ADDRESS: 4204 AND 4206 PARKSIDE AVE

Proposal: Construct rear addition and roof deck with pilot house; rehabilitate buildings

Review Requested: Final Approval Owner: 4204 Parkside Development

District Designation: Parkside Historic District, Significant, 12/11/2009 Staff Contact: Meredith Keller, meredith.keller@phila.gov, 215-686-7660

Roof Top Level П

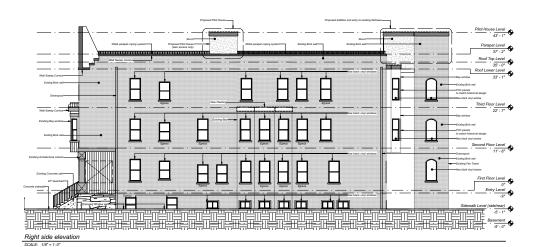
- The proposed roof decks and pilot houses would be inconspicuous from the public rights-of-way. Provided the pilot houses are constructed within and not atop the parapet walls of the historic buildings, the work complies with this standard.

STAFF RECOMMENDATION: Approval, provided the pilot houses are constructed within and not atop the parapet walls of the historic buildings, with the staff to review details, pursuant to Standards 6, 9, and the Roofs Guideline.
